Access Compliance Report

Public Rights-of-Way

(Curb Ramps)

Intersection ID: 50748	Main Street: OPUS_LN	Cross Street: N/A	Location:	E
ADA ID: 2607C8D081E8	Ramp Type: Perp	Initial Pass/Fail: Fail	Overall Compliance: No	Severity Score: 22.5
Codes/Mitigation Info/Possible Solution		Field Measurements/Component Compliance

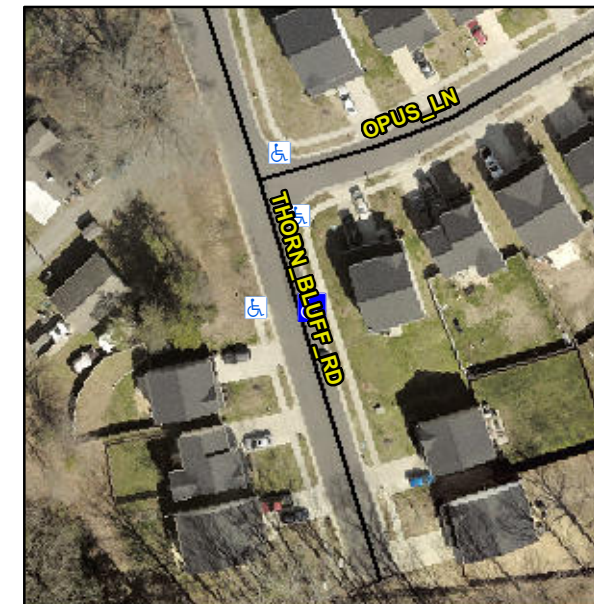
Not Found, R304.5.1, R304.2.2

Compliance	Description	Data	Compliance	Description	Data
N/A	Ramp Length (in)	46.0	No	Ramp Slope (%)	8.9
No	Ramp Width (in)	47.0	Yes	Ramp XSlope (%)	2.2
N/A	Flare Type LT	N/A	N/A	Flare Type RT	N/A
N/A	Flare Slope LT (%)	N/A	N/A	Flare Slope RT (%)	N/A
N/A	Flare Traversable LT?	N/A	N/A	Flare Traversable RT?	N/A
N/A	Landing Length (in)	N/A	N/A	DWS Provided?	N/A
N/A	Landing Width (in)	N/A	N/A	DWS Contrast?	N/A
N/A	Landing Slope (%)	N/A	N/A	DWS Length (in)	N/A
N/A	Landing X Slope (%)	N/A	N/A	DWS Full Width?	N/A
N/A	Landing Curb? (Y/N)	N/A	N/A	DWS Offset (in)	N/A
N/A	Shared Landing?	N/A			
N/A	Gutter Ponding?	N/A	N/A	Gutter Slope (%)	N/A
N/A	Gutter Lip Ht (in)	N/A	N/A	Gutter X Slope (%)	N/A
N/A	Painted X Walk1?	No	N/A	Painted X Walk2?	N/A
	X Walk 1 Direction	To W		X Walk 2 Direction	N/A
N/A	X Walk 1 Width (in)	N/A	N/A	X Walk 2 Width (in)	N/A
	X Walk 1 Slope (%)	3.2		X Walk 2 Slope (%)	N/A
	X Walk 1 X Slope (%)	2.6		X Walk 2 X Slope (%)	N/A

Remove & Replace Entire Ramp.
